Docket Item # 10
BAR CASE # 2006-0283

ISSUE: Appeal of a decision of the Board of Architectural Review, Old and Historic Alexandria, approving a Certificate of Appropriateness for New Construction

LOCATION: 900 North Washington Street

BAR CASE #2006-0283

Figure 3: View of North Columbus Street Elevation as Approved by BAR.

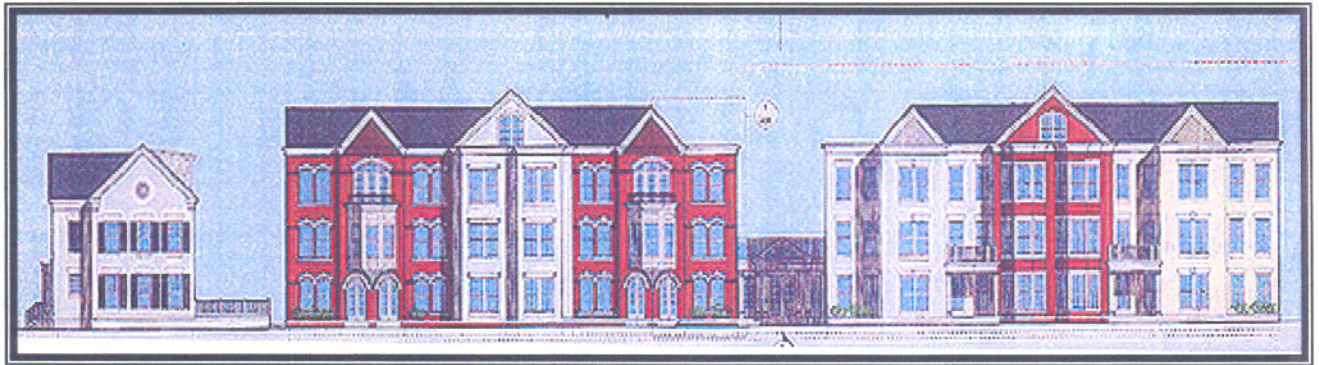
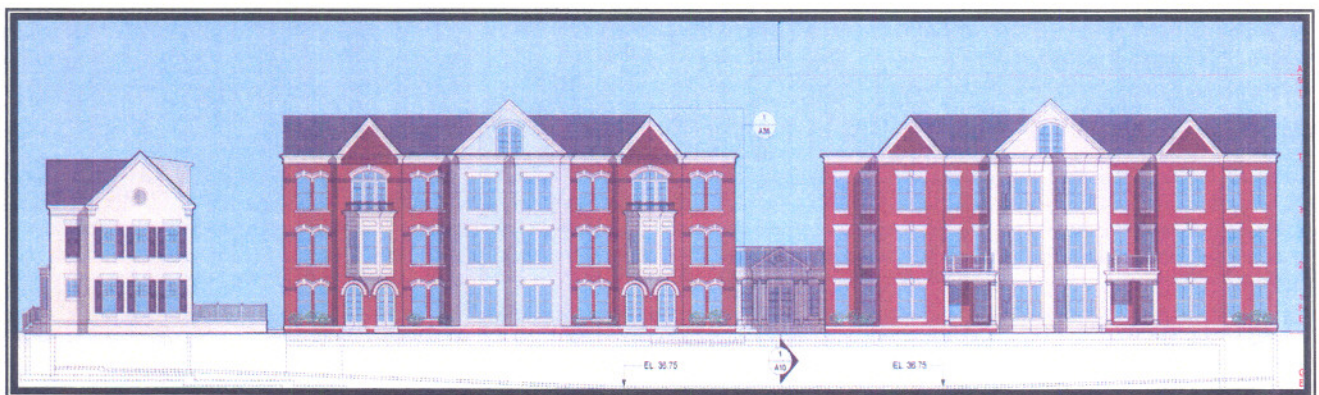
1. Restudy the approach to the height of the buildings fronting North Columbus, exploring options for mitigating appearance of 4th floor, or explore deleting the 4th floor.
2. Restudy approach to window shapes and lintel forms on North Columbus Street buildings, to avoid appearance of fragmented buildings.
3. Restudy the 4 story bay windows, change the 3 story bay windows on North Columbus Street.
4. Restudy the paint color of the North Washington Street building.
5. Restudy the roof shape of the North Washington Street building.
6. Restudy the pediment on the North Washington Street building.

1. The fourth floor was made substantially smaller, and made less visible and prominent by providing increased setbacks and through the use of colors and roof forms.
2. The provision of a functional entrance on North Washington Street for the Washington Street building was incorporated into the design.
3. Additional variety of materials, windows, and detail were incorporated into the project to comply with the Washington Street Standards.

Figure 7 - Proposed Powhatan Street elevation for Certificate of Appropriateness Review

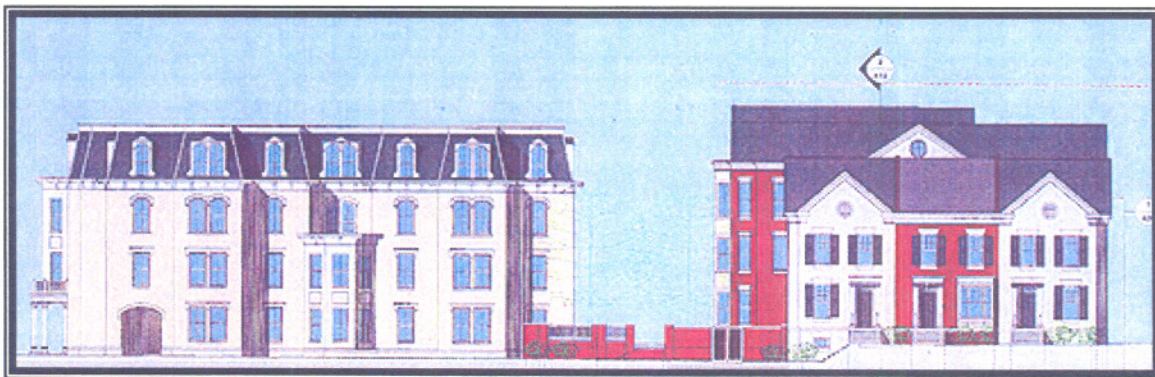
The two buildings relate to one another but have different bay and window rhythms, porch expressions, and color. In respect to materials, the building share painted and natural brick as the primary exterior material, wood trim, precast stone lintels, wood and iron railings, and slate roofs.

Figure 9 - Proposed Montgomery Street elevation for Certificate of Appropriateness Review

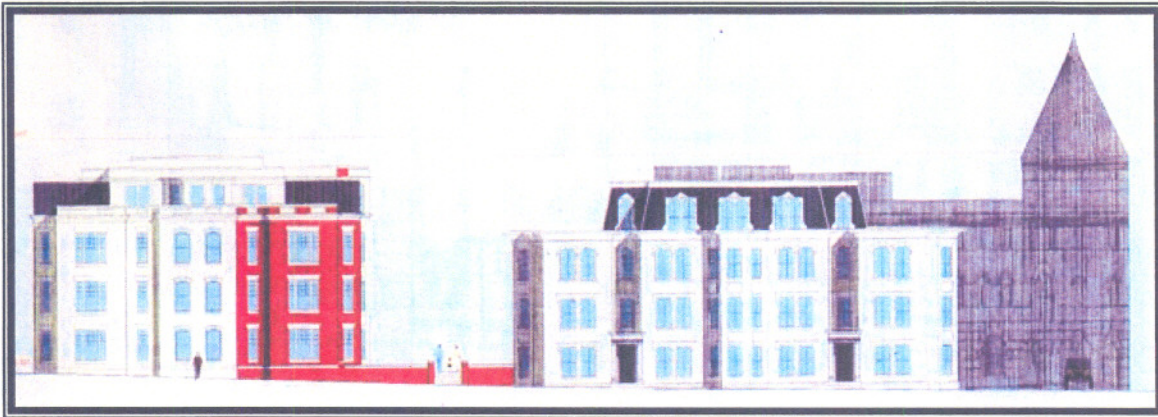
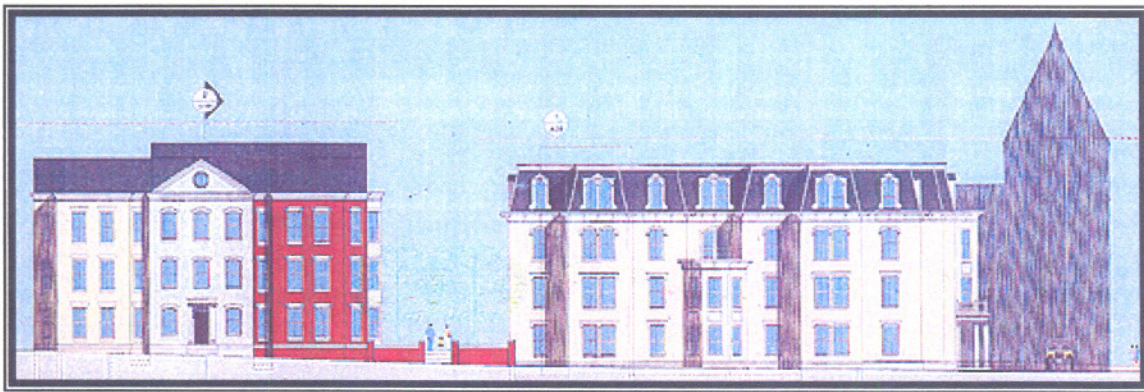
This is an element which has been positive and has continued to improve with the revisions to the plan. Three connected townhouses are now shown, each with two bays. The height of the stoops have been lowered and side gabled roofs have been added, with slate roofing. All of these elements combine to create a very successful form, mass and scale for these buildings. The units have also been refined to include window and bay elements compatible with the adjoining townhomes, (the Old Town Gateway project.) Windows have been incorporated below the water

table and on the sides of the projecting pavilion elements. Wood operable shutters, sized to fit the window openings have also been added.

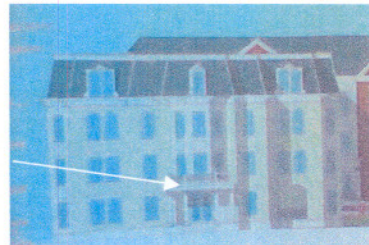
2. The roofline for the condominium buildings that face both Columbus and Washington Street must be broken up to look separate. (*Washington Street Standard requirement*)

3. Entrance of the building on corner of Washington St., Montgomery St. and Powhatan Street, must be made larger so that it is proportional to the overall size of the building as illustrated by the Cotton Manufactory. (*Washington Street Standard requirement*)

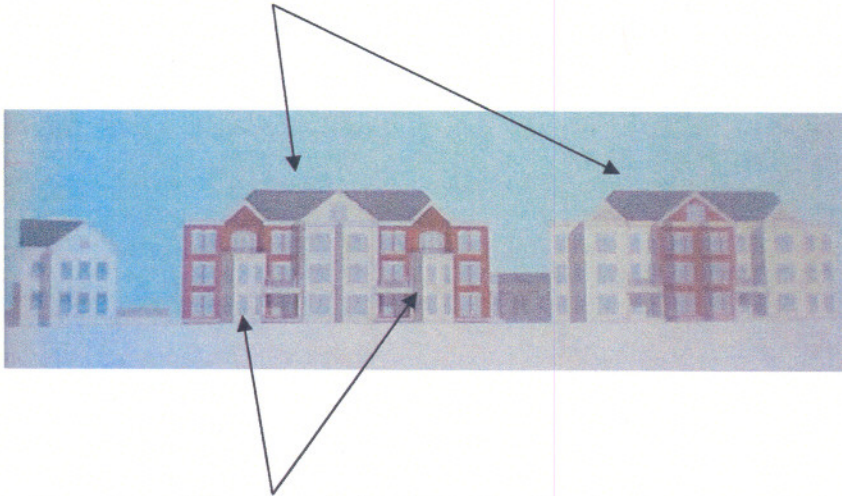
4. The materials and ornamentation be of quality found on, buildings of historic architectural merit found on Washington Street, including the use of self-bearing masonry and punched out windows. (*Washington Street Standard requirement*)

5. The roofline for the condominium buildings that face both Columbus and Washington Street must be broken up to look separate. (*Washington Street Standard requirement*)

6. Recommend that the window bays should only cover one story instead of two as proposed above. The styles found on 417 and 207/208 North Washington Street show how single stories bays are used as a strong focal point to break up the massing.
